## **Addendum #02 for RFB #911800-02**

Project Name: IVH-Mechanical & Electrical Distribution System Replacement

Addendum #2:

Iowa Veterans Home  
Power Plant Upgrades – DAS #9118.00  
Addendum #2

Drawing Name:  
**SITE NOTES AND  
REQUIREMENTS**

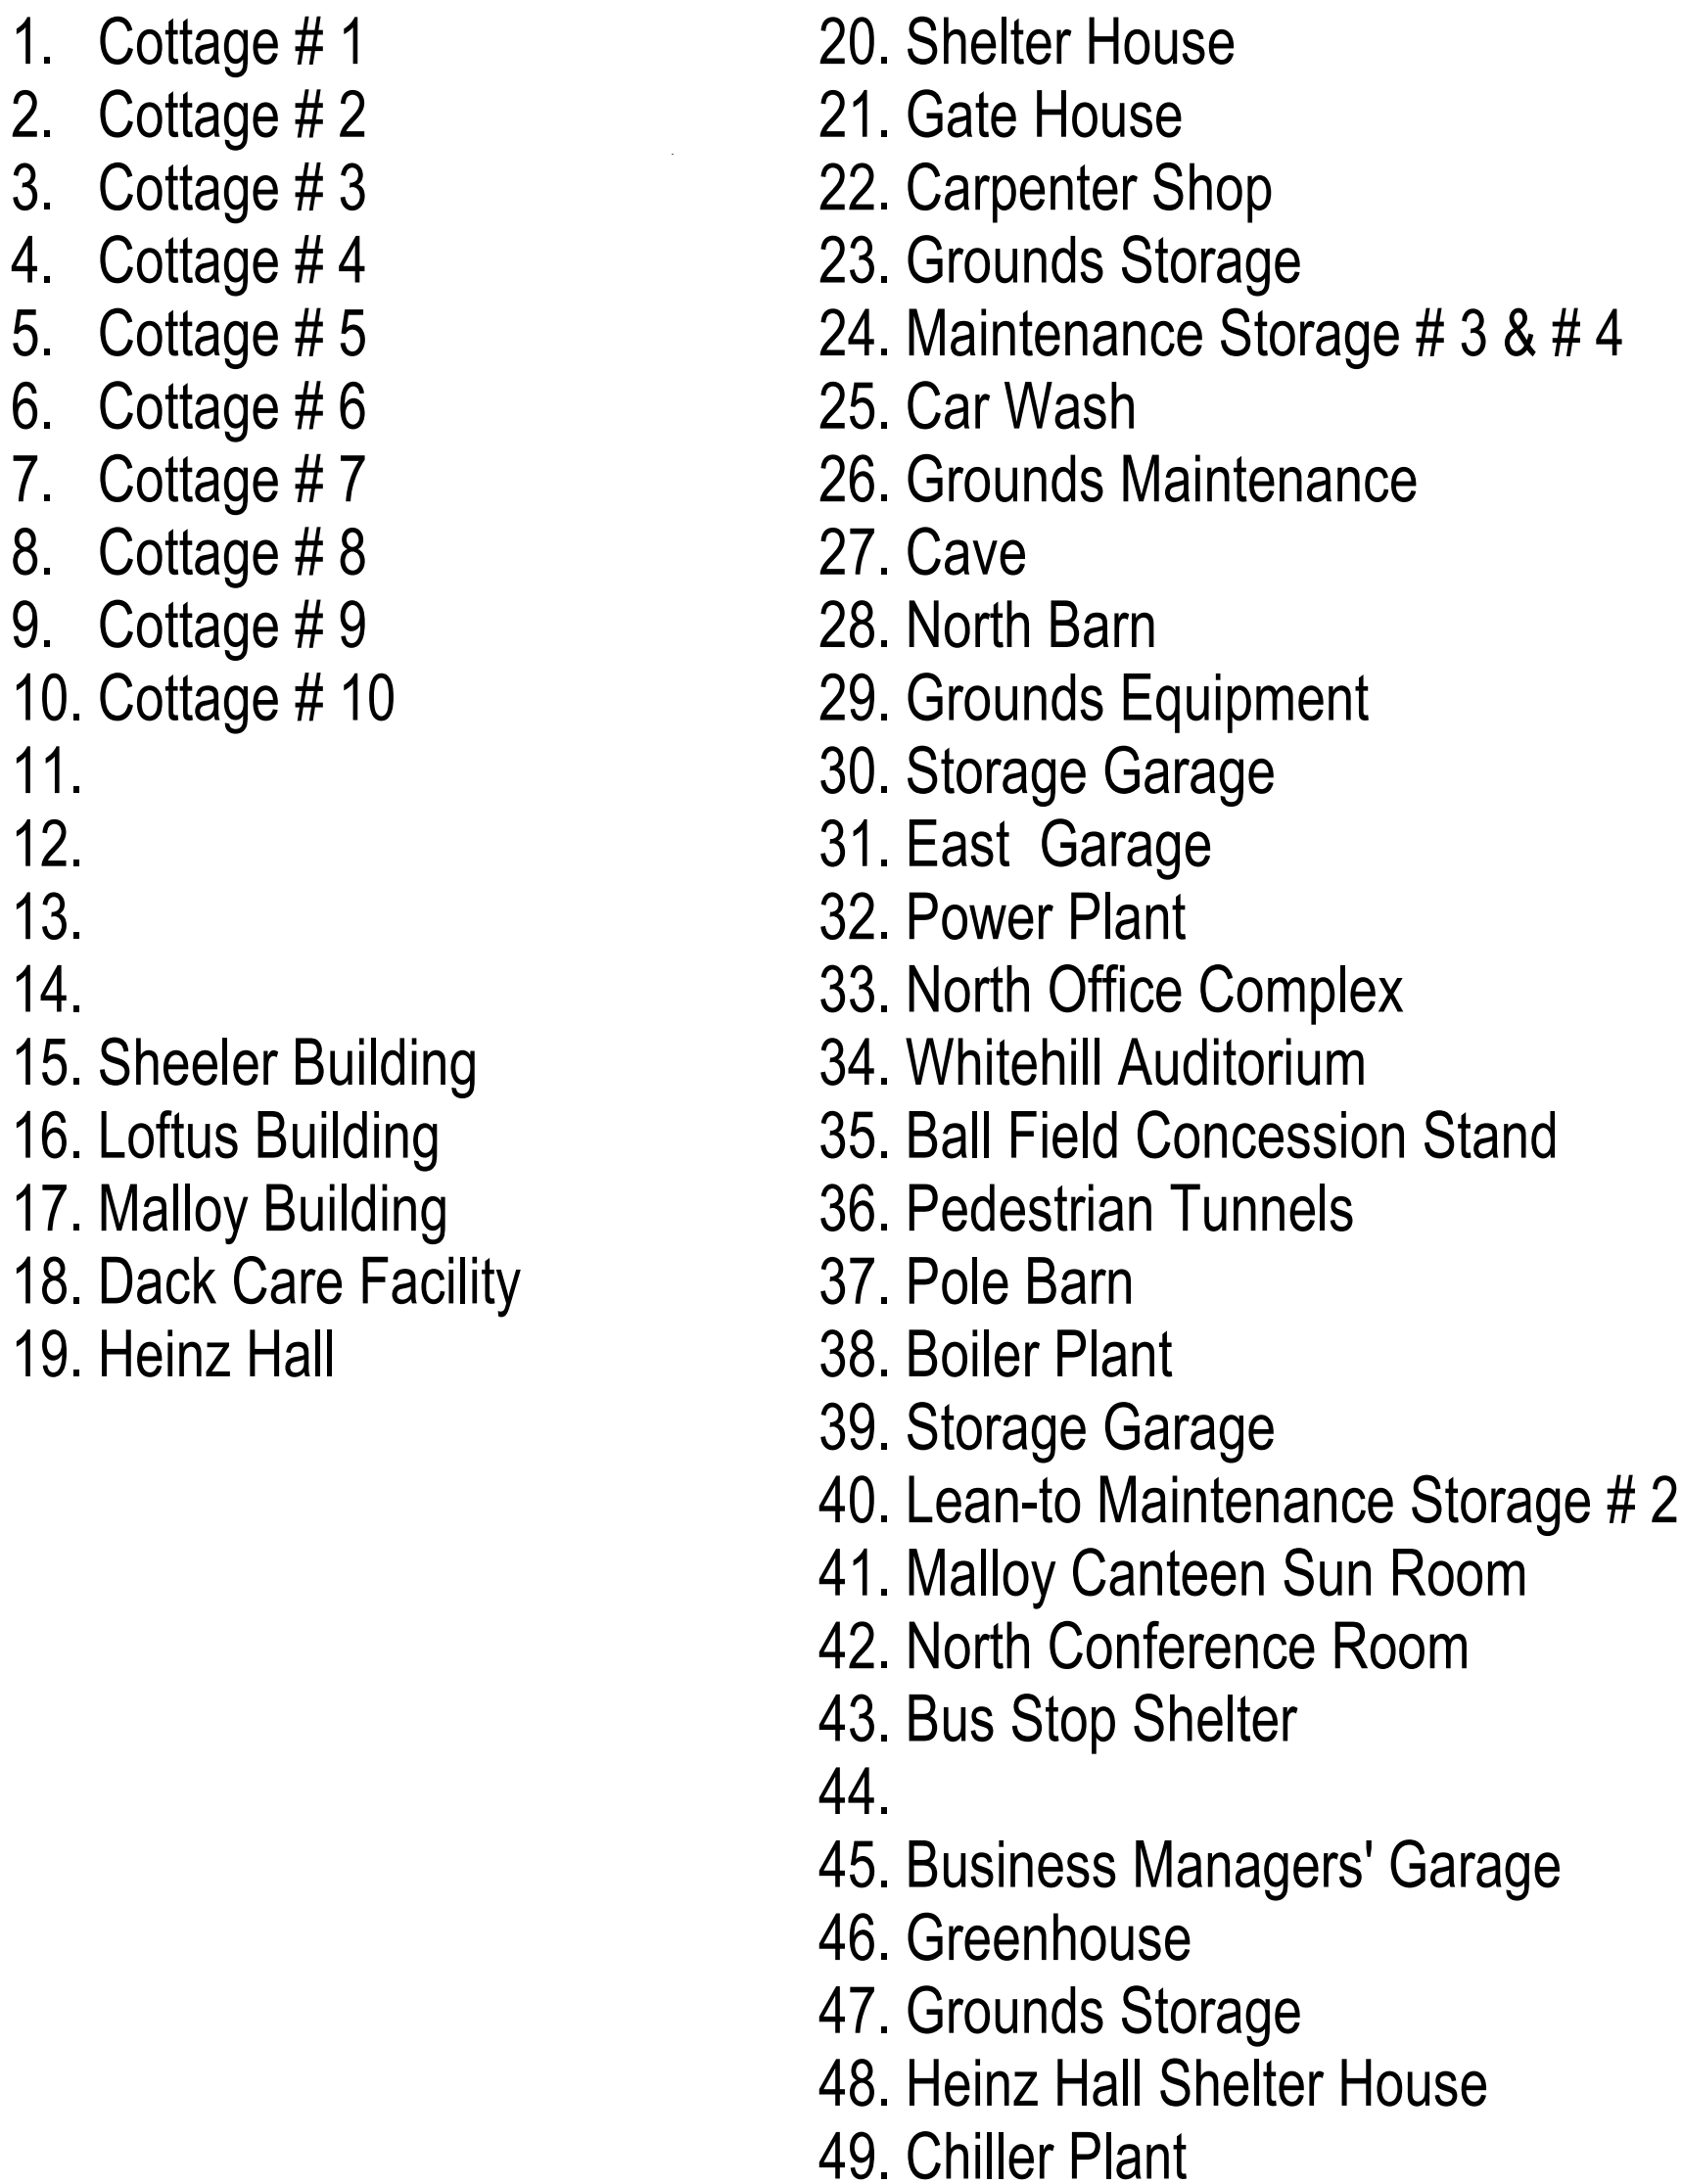
- Do you have any thoughts on how much fencing we will need?
  - Refer to revised sheet M002. Roughly 540 LF with one drive through gate.
- Who is the water treatment supplier currently maintaining the facility?

1 ENLARGED LOWER LEVEL MECHANICAL PLAN - NORTH  
SCALE: 1/4" = 1'-0"

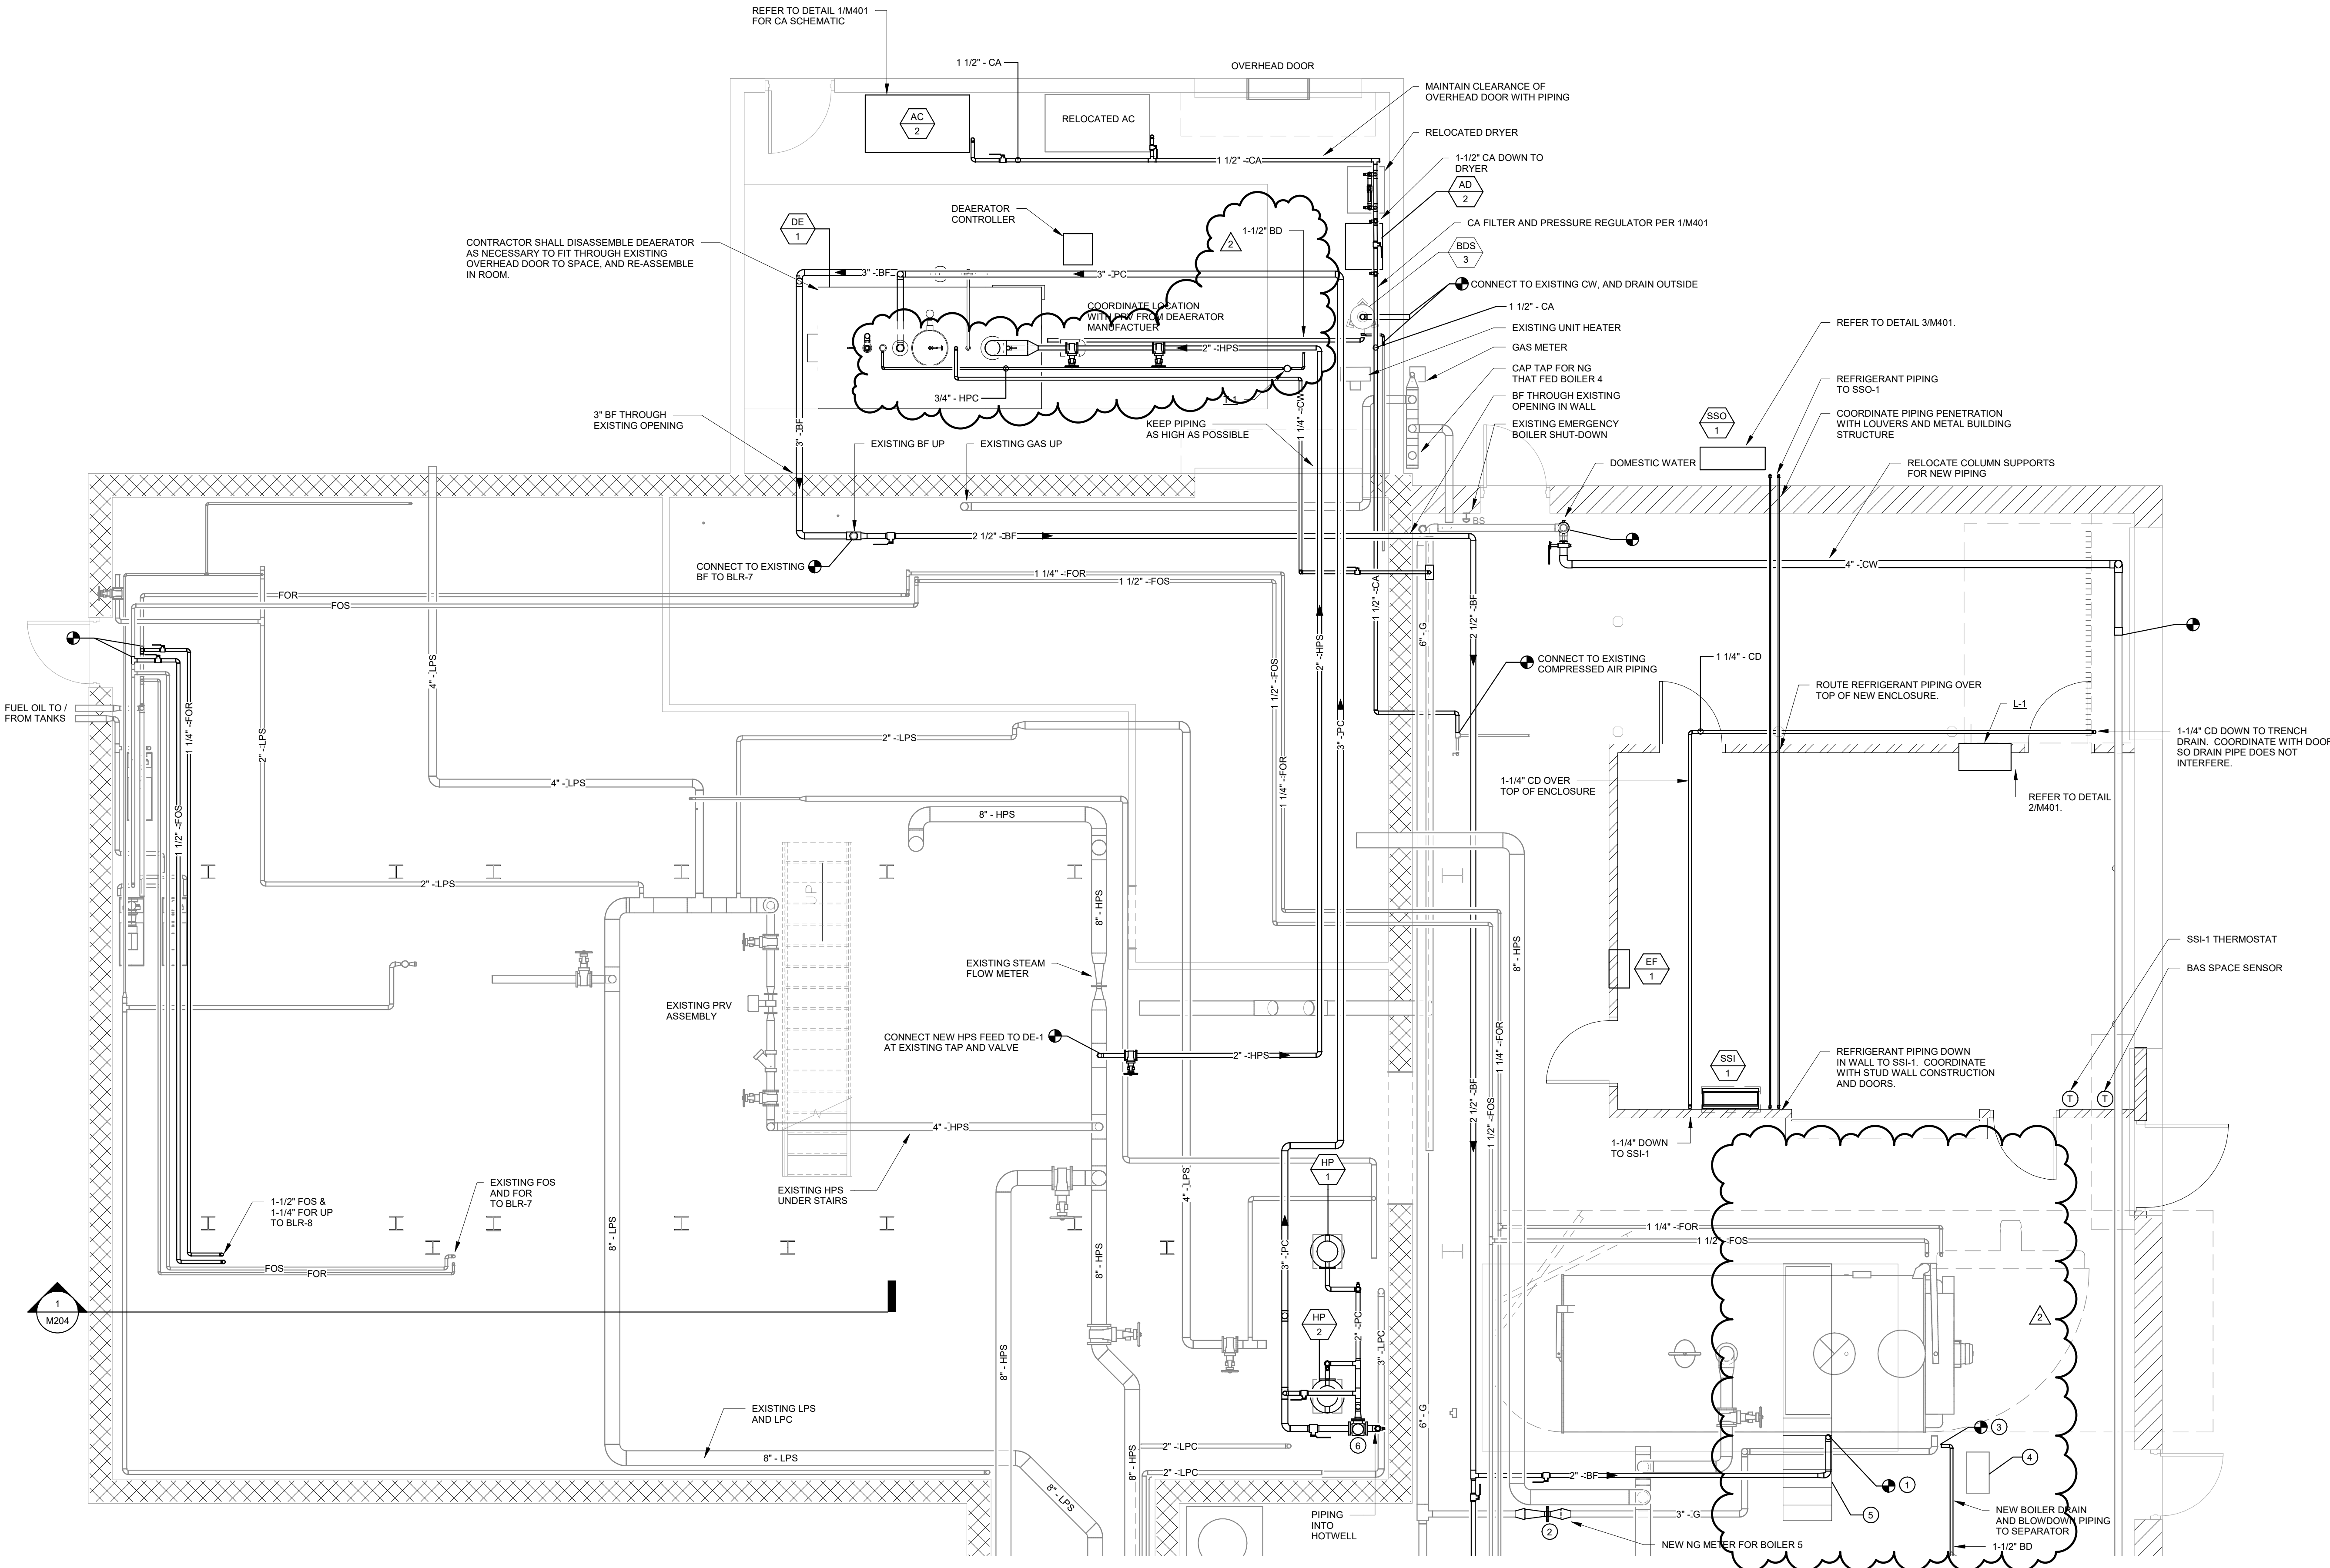
- 4. Drawing M200 Enlarged Mechanical Plans
  - a. **CLARIFY** no motorized damper is necessary behind louver L-1.

- b. **ADD** ¾" HPC with steam trap **T-1** at where 2" HPS turns east toward DE-1. Route ¾" HPC to DE-1 and connect to DE-1.
  - c. **ADD** label to piping from DE-1 to BDS-3 as 1-1/2" boiler drain.

- d. **ADD** Keynote 5 at north side stair of Boiler 5.
- 5. Drawing M201 Enlarged Mechanical Plans
  - a. **REVISE** Keynote 6: Provide new connection from cooling tower chemical treatment system into condenser water piping with one PVC pipe manifold and shut-off valve for treatment, and one inch pipe and shut-off valve for connection to blowdown valve.
